Reference No. 4770

Re: Revisions to Proposed Removal Action
Textile Road Site, Washtenaw County, Michigan

The purpose of this letter is to summarize proposed amendments to the Work Plan and the Proposed Plan. These suggested amendments have been agreed to by the Group and the Township. The suggested amendments are intended to optimize the redevelopment potential of the property following the RA. This letter is presented in the following Sections:

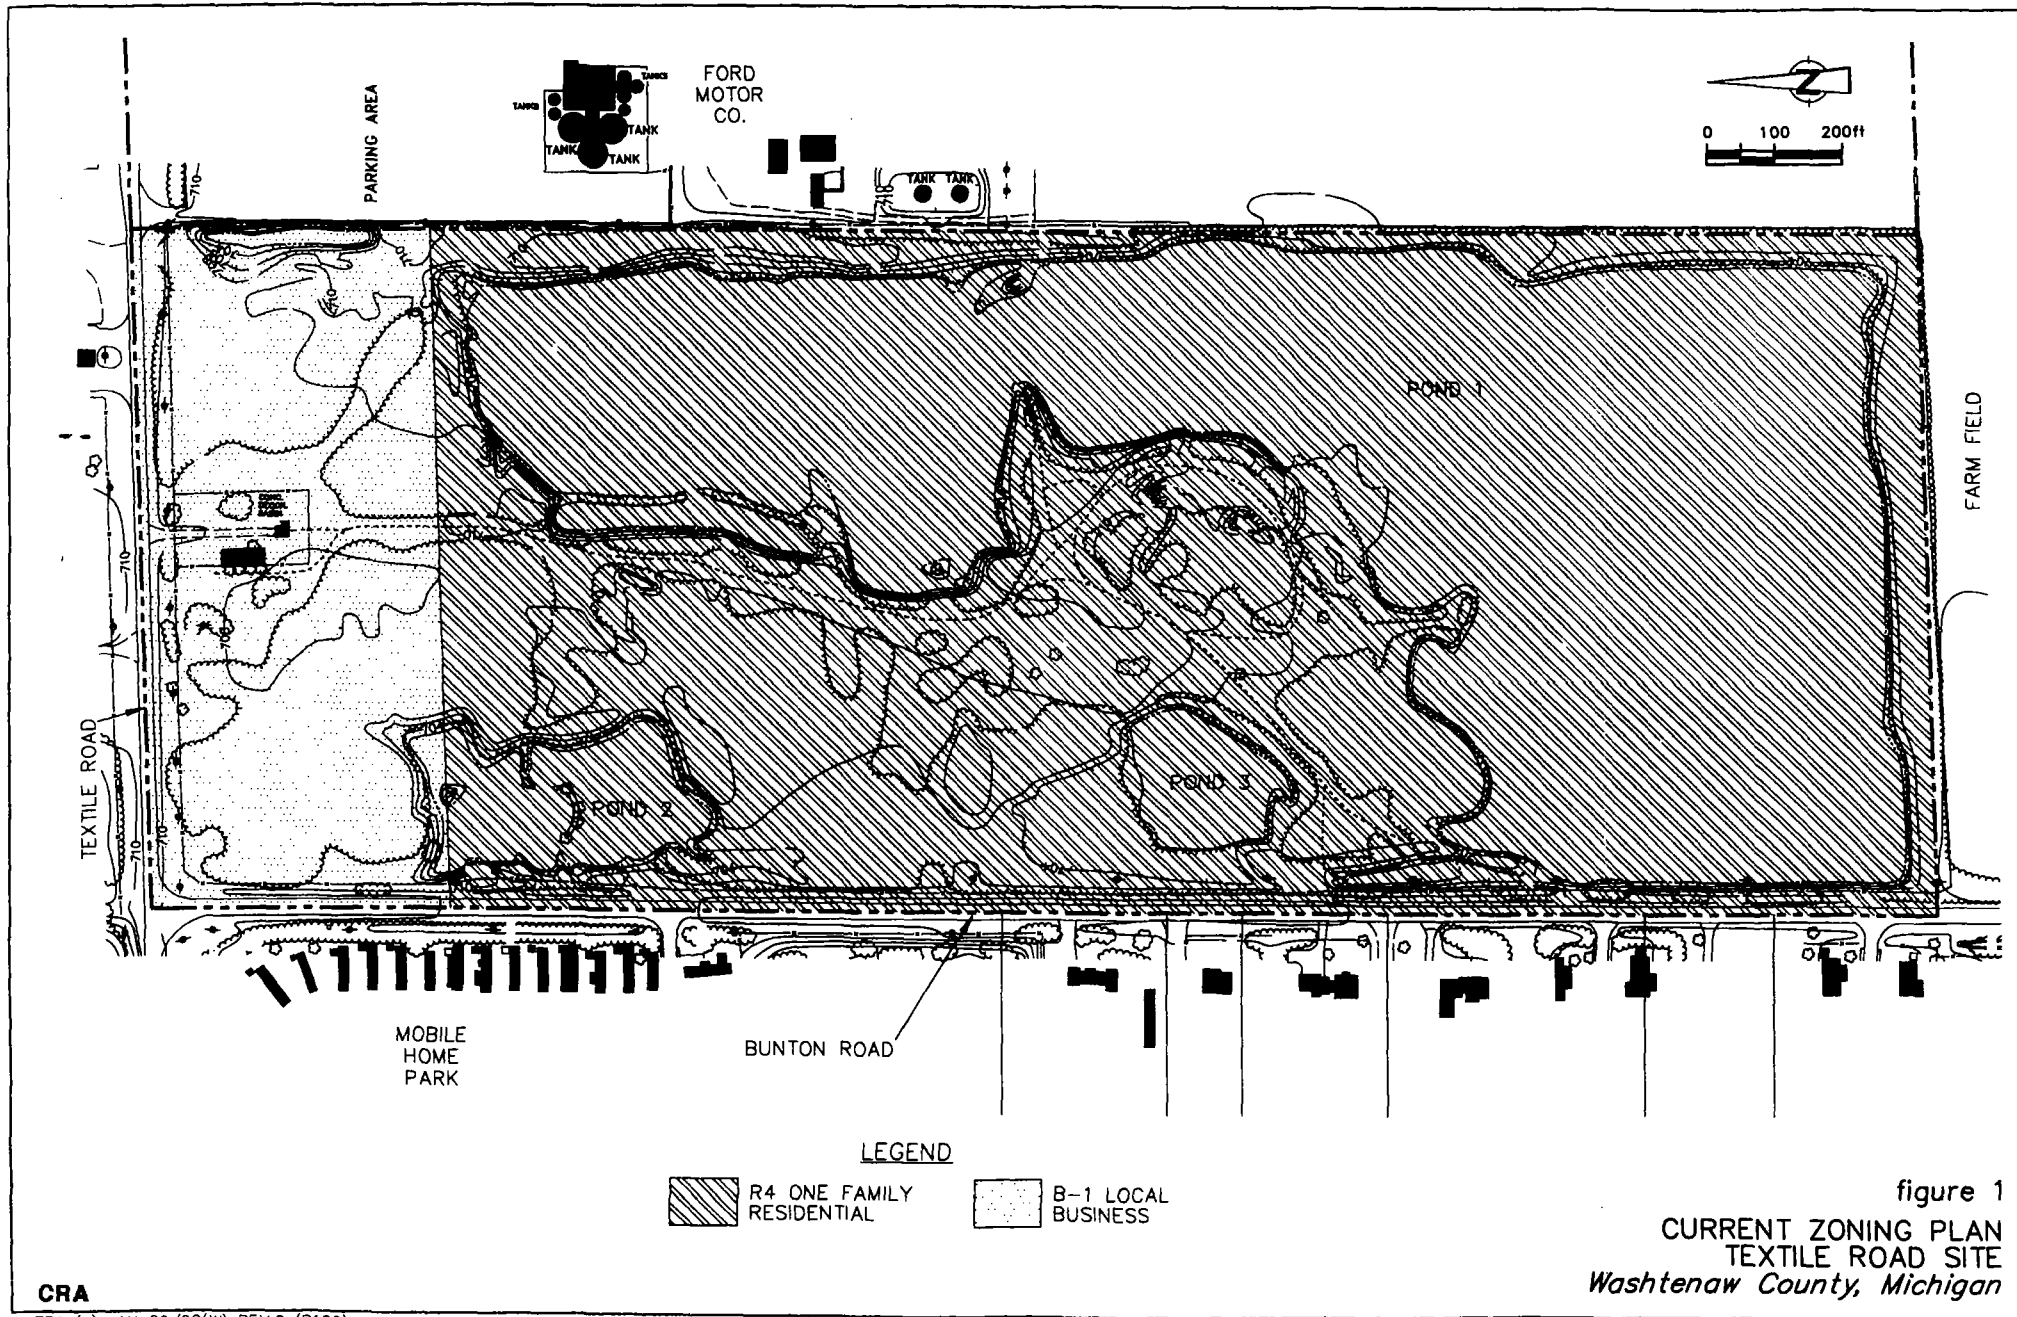
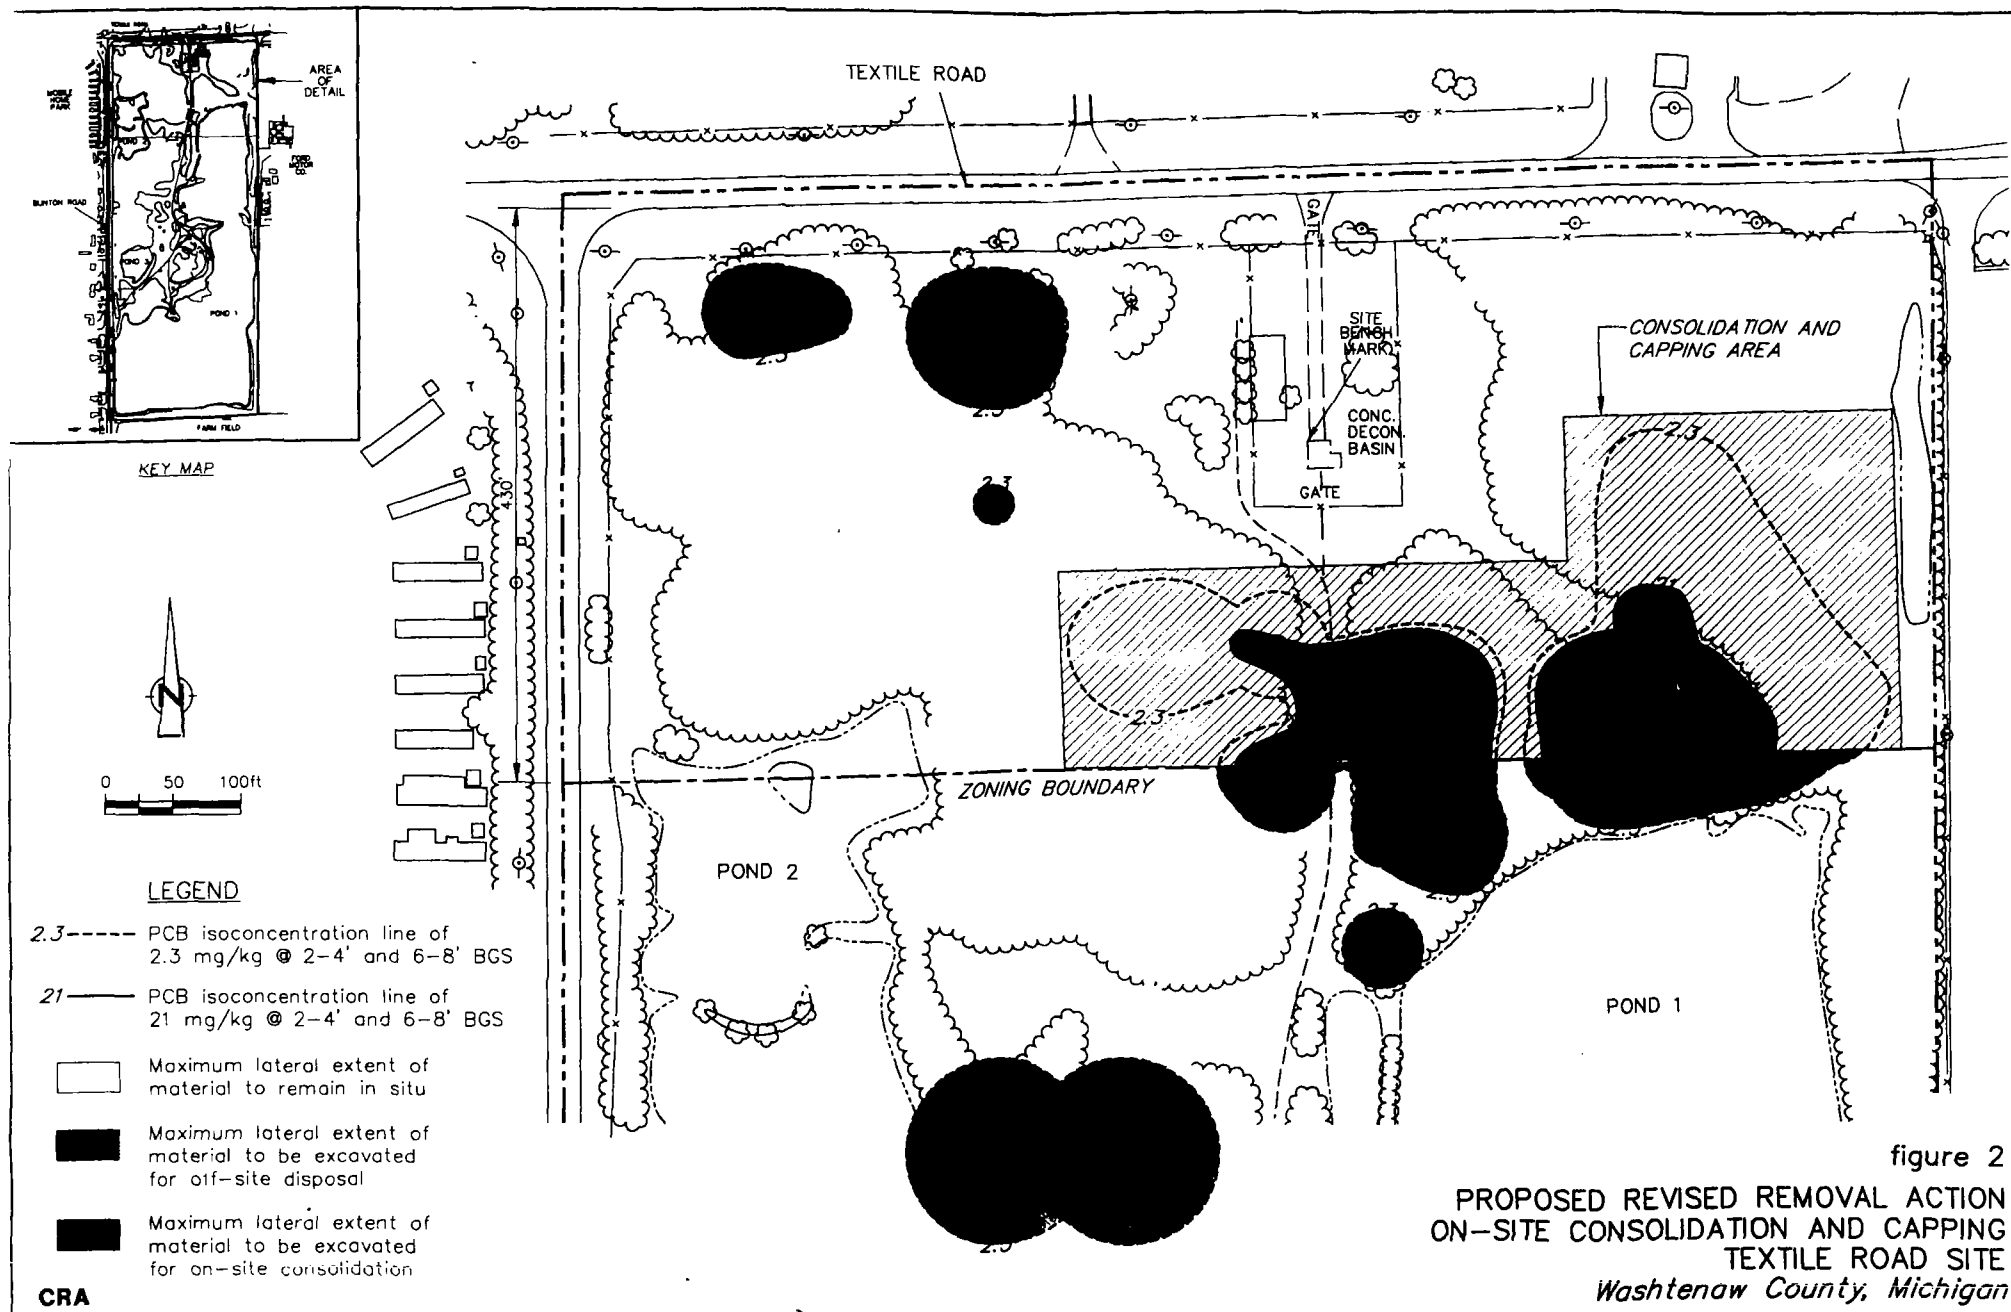
- Material south of the portion of the Site zoned local business which is contaminated with PCBs above the Michigan Act 451, Part 201 Generic Residential Soil Direct Contact Value of 2.3 mg/kg will be excavated;
- Additional material located in the northwest corner of the Site which is contaminated with PCBs above the Michigan Act 451, Part 201 Generic Residential Soil Direct Contact Value of 2.3 mg/kg will be excavated;
- Excavated material containing PCB concentrations between 2.3 mg/kg and 21.0 mg/kg will be consolidated to the area north of Pond 1 (see Figure 2). This material will be used as backfill in place of "clean" on-Site borrow material as proposed in the RA Work Plan, as applicable;

- Areas of Site in the residential portion and northwest corner where the above excavations occur will be backfilled with "clean" on-Site borrow area material; and
- Areas of the Site which continue to contain material contaminated with PCBs between 2.3 mg/kg and 21.0 mg/kg (the consolidation area) will be covered/capped with "clean" on-Site material, six inches of topsoil, and a vegetative cover, or other capping system (eg. commercial building and/or parking lot) which supports future development of the property and is approved by the U.S. EPA.

The additional excavation, consolidation, and capping areas discussed above are illustrated on Figure 2. The contours presented on Figure 2 were developed based on the PCB isoconcentration contours from 2-4 feet below ground surface (bgs) and 6-8 feet bgs and represent the estimated maximum lateral extent of contamination at the Site.
